SUBJECT: Installation procedure

SUBJECT: SC506

MODEL:3.5K LCT for
F400 series

4. Caution when installing the LCT (large capacity tray service manual - installation procedure, page 12)

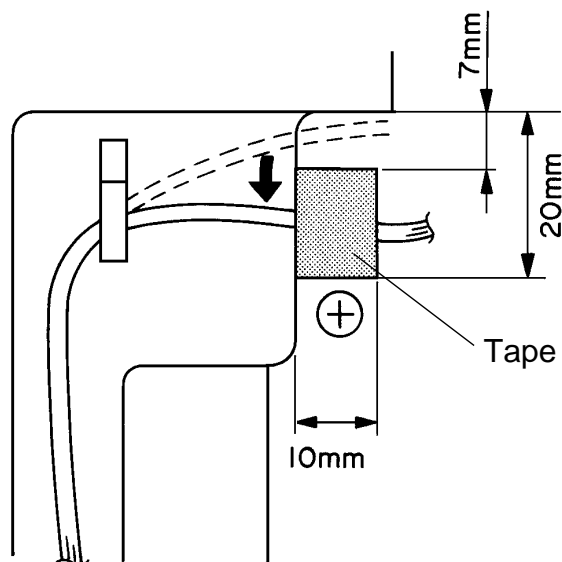
When installing the tray unit [A] to the LCT connector [B], be careful not to pinch the harness between the feed unit bracket [C] and the tray unit bracket [D], as shown.

To prevent this, fix the harness with a tape as shown before installing the tray unit.

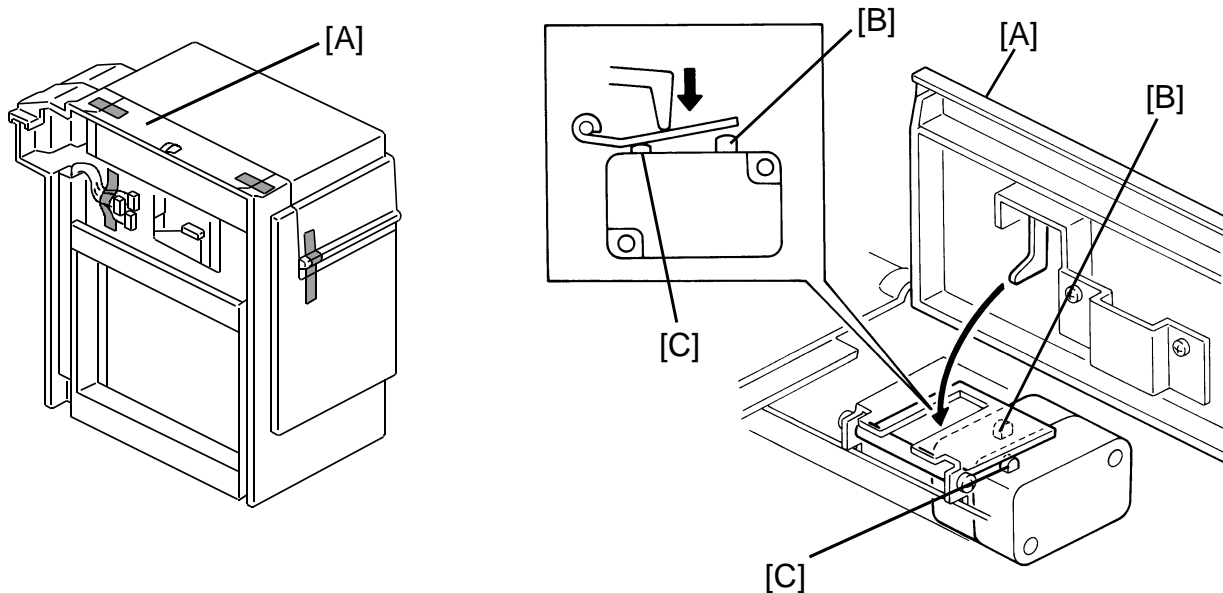
There are two micro switches detecting the 3.5K LCT small cover [A] open condition.

One switch [B] is a safety switch for cutting the power to the motors when the door is opened.

The other switch [C] sends a signal to the copier main control board. This cover open signal is used to indicate the cover open condition on the operation panel and prohibits the copying.

When the cover [A] is opened, both switches should be actuated.

When the door [A] is closed incompletely, it is possible that only the signal switch [C] is actuated. In this case, the operation panel does not indicate the door open condition and the print key is green. If the customer selects the 3.5K LCT and presses the print key, the LCT feed motor does not rotate and SC506 is displayed.

(If only the safety switch [B] is actuated, operation panel indicates the open condition correctly).
